SUBMISSION FOR DEPARTURE FROM STANDARDS

PROJECT NAME	Connected Communities – Great North Road Detailed Design
APPLICANT ORGANISATION	██████████
CONTACT DETAILS:	██████████ – ██████████
APPLICANT REF	
HIGHWAY AUTHORITY REF	
DATE SUBMITTED	18/03/2022

1. SISD east of Harcourt Street and MGSD west of Elgin Street

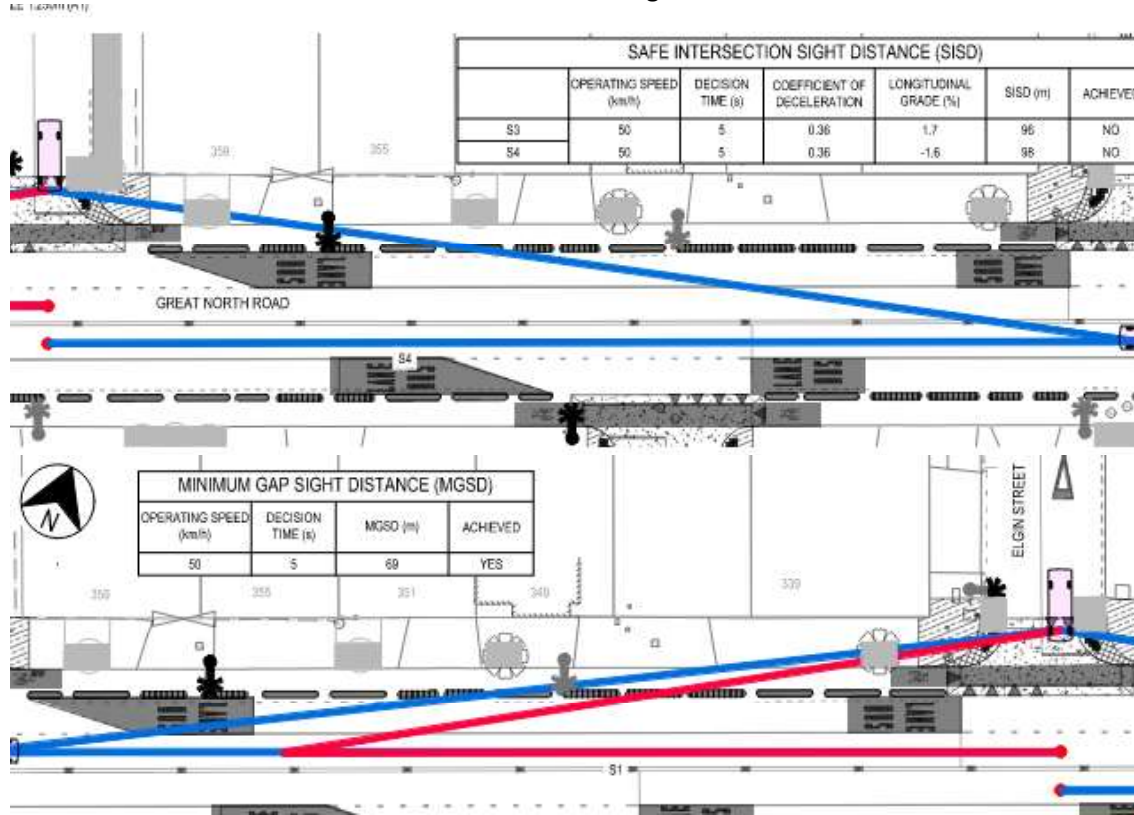
Design seeks a departure to achieving either SSD or MGSD at the following locations where new parking locations are proposed as a result of public consultation.

The locations propose to use the following sight distance parameters to achieve proposed additional parking.

1. Between Harcourt Street and Elgin Street
 - a. Right turn movement out of Harcourt Street – MGSD of 111m
 - b. Left turn movement out of Elgin Street – SSD of 84m
2. Between Ariki Street and Turakina Street
 - a. Right turn movement out of Ariki Street – MGSD of 111m
 - b. Left turn movement out of Turakina Street – SSD of 75m
3. Between Potatau Street and Brisbane Street
 - a. Right turn movement out of Brisbane Street to use existing sight lines based off existing parking locations due to low volume nature of Brisbane Street
 - b. Left turn movement from Potatau Street – SSD of 74m

Reviewer	Andy Irwin - Principal SME Transport Design	Signature		Date	20/11/2024
Approver	Richard westerman Transport Design SME Mgr	Signature		Date	26 November 2024
Decision	<input type="checkbox"/> Approved <input checked="" type="checkbox"/> Approved with comments <input type="checkbox"/> Rejected with reasons				
*COMMENTS or *REASONS FOR REJECTION (*delete as applicable)	Monitor behaviour after construction to review acceptable intersection performance

3. MGSD east of Potatau Street and SISD west of Brisbane Street

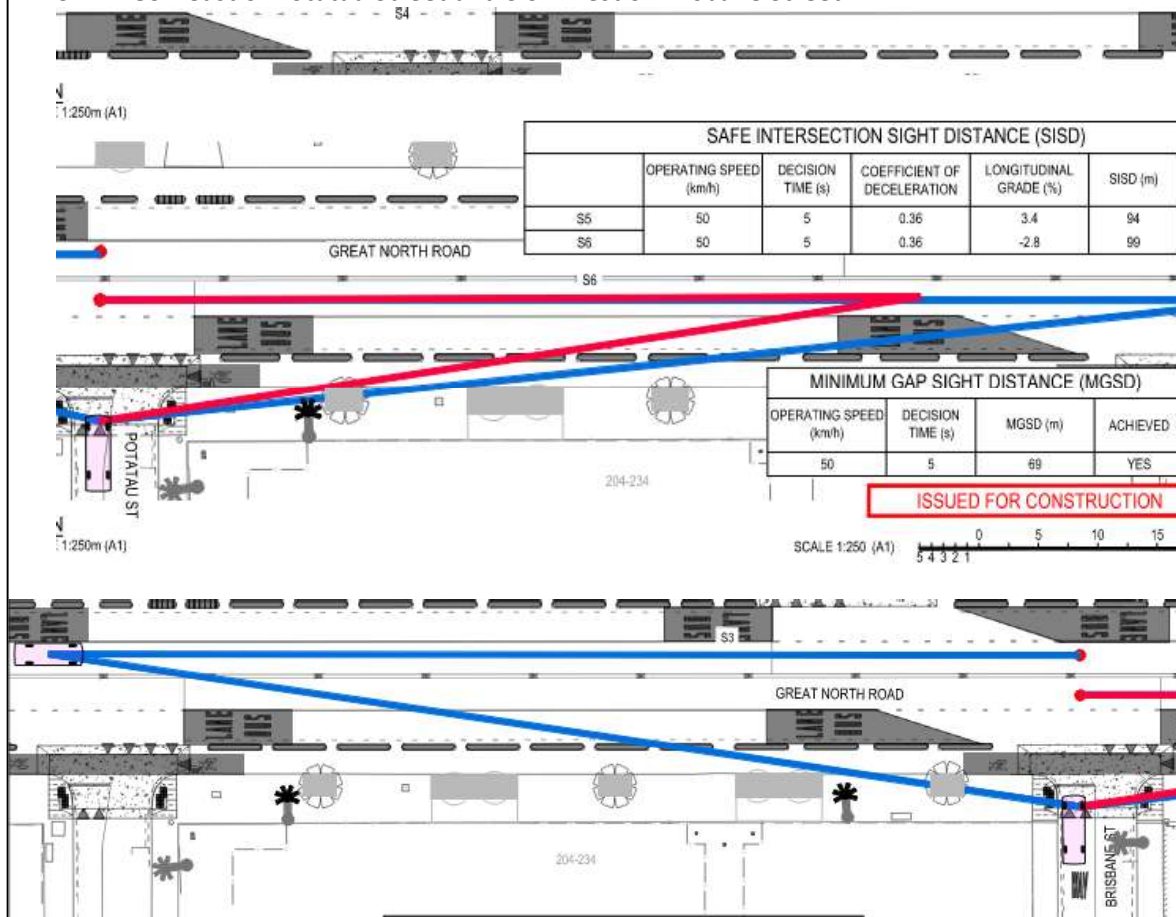
For Brisbane Street, due to the low traffic volumes expected for a dead end street, a “no worse than existing” approach was taken for the sight distances. This was undertaken using the existing carparking extents and identifying the resulting sightlines.
